C2M EYE-MASK FIGURE 120E-13 UPDATE PROPOSAL

IEEE 802.bs Adhoc Meeting

October 17, 2016

Figure 120E-13—PAM4 eye measurements

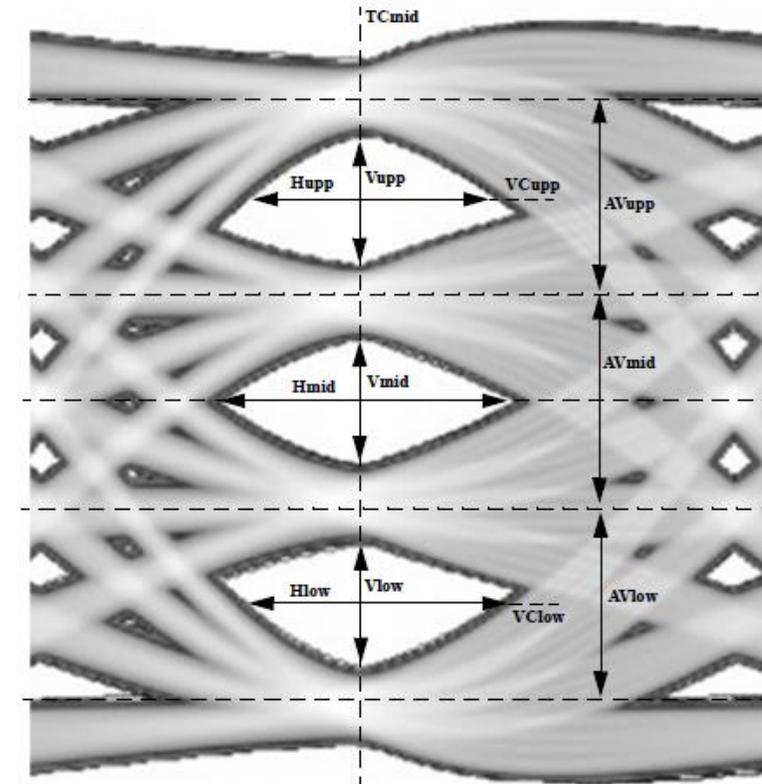
“Section 120E.4.2 Eye Width and Eye Height Measurement Method” includes terminology that it is not reflected in the corresponding Figure 120E-13 and vice versa.

1. +1/3 (MIDCDF1) and -1/3 MIDCDF0 are mentioned in text but there is no reference in corresponding figure.
2. MIDCDF0, MIDCDF1, LOWCDF0, LOWCDF1, UPPCDF0, UPPCDF1 are mentioned in text but there is no reference in corresponding figure.
3. VCmid is mentioned in text but there is no reference in corresponding figure.
4. MIDOCDFL, MIDOCDFR are mentioned in text but there is no reference in corresponding figure.
5. Since VEC equation was deleted per comment #173 against draft Rev 2.0, remove from subject figure the references Avupp, Avmid, Avlow.

Proposed Edits to Figure 120E-13

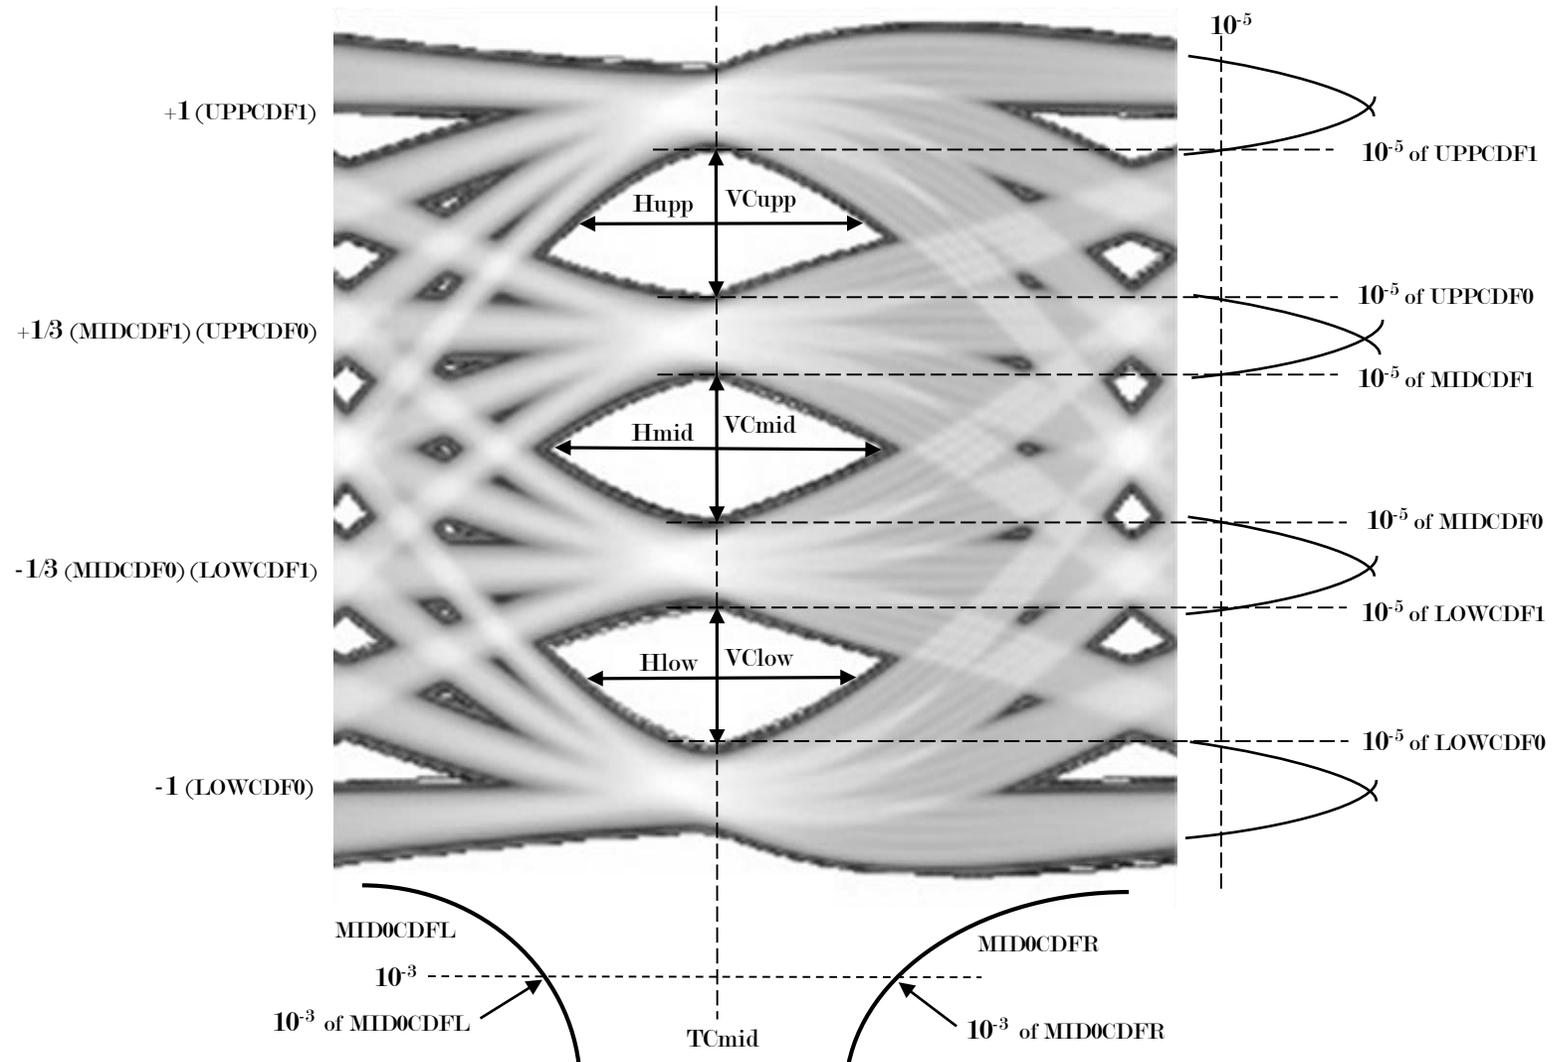
1. MIDCDF0, MIDCDF1, LOWCDF0, LOWCDF1, UPPCDF0, UPPCDF1 are mentioned in text but there is no reference in corresponding figure.

2. VCmid is mentioned in text but there is no reference in corresponding figure.

3. MIDOCDFL, MIDOCDFR are mentioned in text but there is no reference in corresponding figure.

4. Since VEC equation was deleted per comment #173 against draft Rev 2.0, remove from subject figure the references Avupp, Avmid, Avlow.

Solution: Add MIDCDF0, MIDCDF1, LOWCDF0, LOWCDF1, UPPCDF0, UPPCDF1 to Figure 120E-13

Solution: Add VCmid to Figure 120E-13

Solution: Add MIDOCDFL, MIDOCDFR to Figure 120E-13
